Our Case Number: ABP-307652-20

**Re:** Construction of the Boyne Greenway, pedestrian and cycleway linking Drogheda Town in Co. Louth to Mornington Village in Co. Meath  
Townlands at Ship Street in Drogheda, Co. Louth to Mornington Village in Co. Meath

### **Re: Construction of the Boyne Greenway, pedestrian and cycleway linking Drogheda Town to Mornington - Request for Information Letter**

**Figure 1: Route Alignment drawing – Notes & Legend**

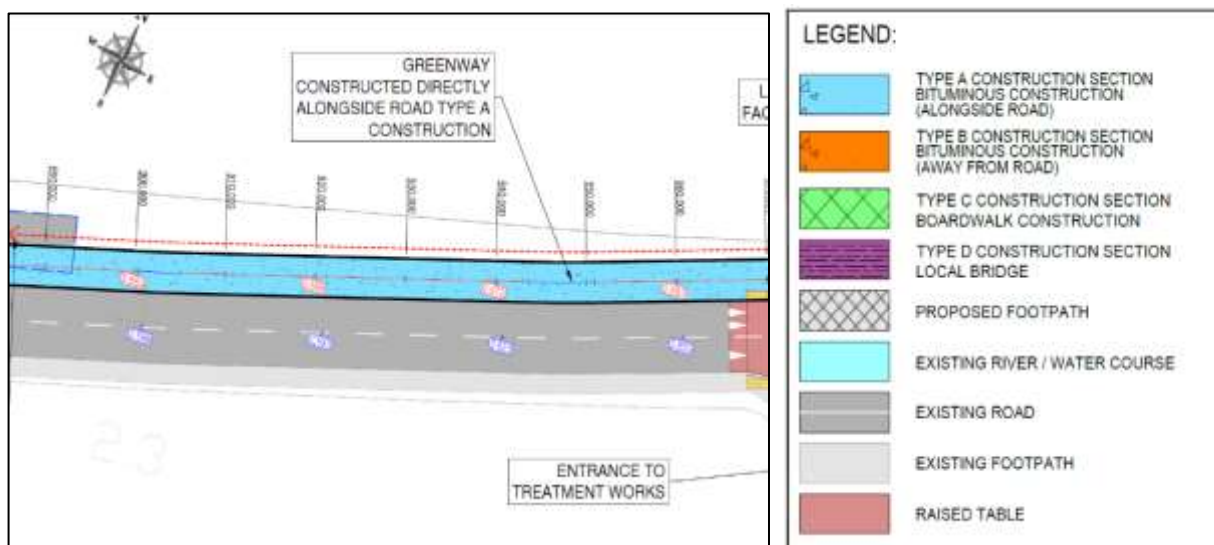
...how much of the route is to be constructed directly alongside the Regional Road

The Route Alignment drawings (170029-2200 to 170029-2240), issued as part of the planning package, illustrates where the greenway is adjacent or away from the Regional Road, along with notes and colour coded hatching of the greenway route (see Figure 1 below).
